Re: Township of Esquimalt Application for Rezoning and Subdivision of 901 Selkirk Ave

From: pg <
Sent: July-02-18 1:56 PM
To: 'Denise Kors'
Cc: Bill Brown
Subject: RE: Proposed rezoning of 901 Selkirk Ave

From: denise@korsdevelopment.com
Sent: September-05-18 12:27 PM
To:
Cc: Bill Brown
Subject: Proposed Rezoning of 901 Selkirk Ave
Attachments: Letter from 905 Selkirk Ave, June 27, 2018.pdf; Streetscape Selkirk 3.jpg; Tree Inventory - Tree Retention Plan 20180522.pdf; arborist report 20180523.pdf

Rooftop deck (101 Uganda) as an intrusion on the privacy of residents in nearby properties

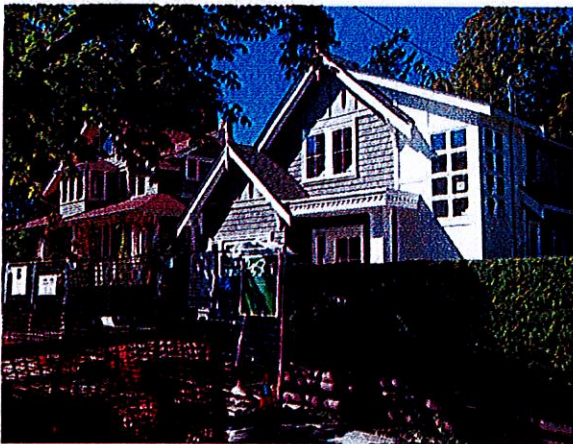
(2) Major design concern: rooftop decks proposed for the two houses facing Selkirk.

The proposal to build rooftop decks on two of the houses is very inappropriate for an older residential neighbourhood such as surrounds 901 Selkirk. The proposed design also contravenes Esquimalt's *Official Community Plan* (adopted June, 2018) guideline for infill housing that states "Windows, decks and patios should be located so as to minimize intrusion on to the privacy of adjacent properties" (p. 87).

The rooftop decks proposed for the two homes facing Selkirk Ave. would provide unrestricted views over and into the private back-yard spaces of many families living in the vicinity of the proposed development. The intrusive "overview" impacts are exacerbated because the majority of existing properties are located *downslope* from the proposed new homes. Please see the photos below, of the recently-constructed (by the applicant for 901 Selkirk) home 101 Uganda St., noting in particular how its rooftop deck is perched high above several neighbouring properties.

In established neighbourhoods such as ours, backyard spaces of all homes are available – and intensively used – as personal private space for activities that range from gardening, to relaxation/reading, play-space for children, family barbecues, entertaining guests, etc. Home-owners have the option of determining degrees of privacy from neighbours through variations (e.g. type, height) in fences and screens that they construct. The proposed rooftop decks at 901 Selkirk – like the one on the photographed house at 101 Uganda – provide no such remedy for other homeowners in the neighbourhood whose private backyard spaces are now open to surveillance from people on the rooftop decks. This loss of privacy, for some, will have a "chilling" effect on their use of backyard space in general and for certain types of private activities (e.g. sun-bathing).

The *proposed construction of roof-top decks on these new homes must be disallowed, (a) because the design conflicts with the stipulation of the Official Community Plan (quoted above) and (b) specifically to protect the rights to privacy in backyard spaces of other residents of the neighbourhood.* The proposed new homes each have back yards that may be developed with low-level decks and patios, gardens, and play spaces (also with different fencing options), like those of other homes in the neighbourhood. ("Any proposal for single-unit infill housing should provide for usable, private outdoor areas for each dwelling, at grade", *Official Community Plan*, p. 87).
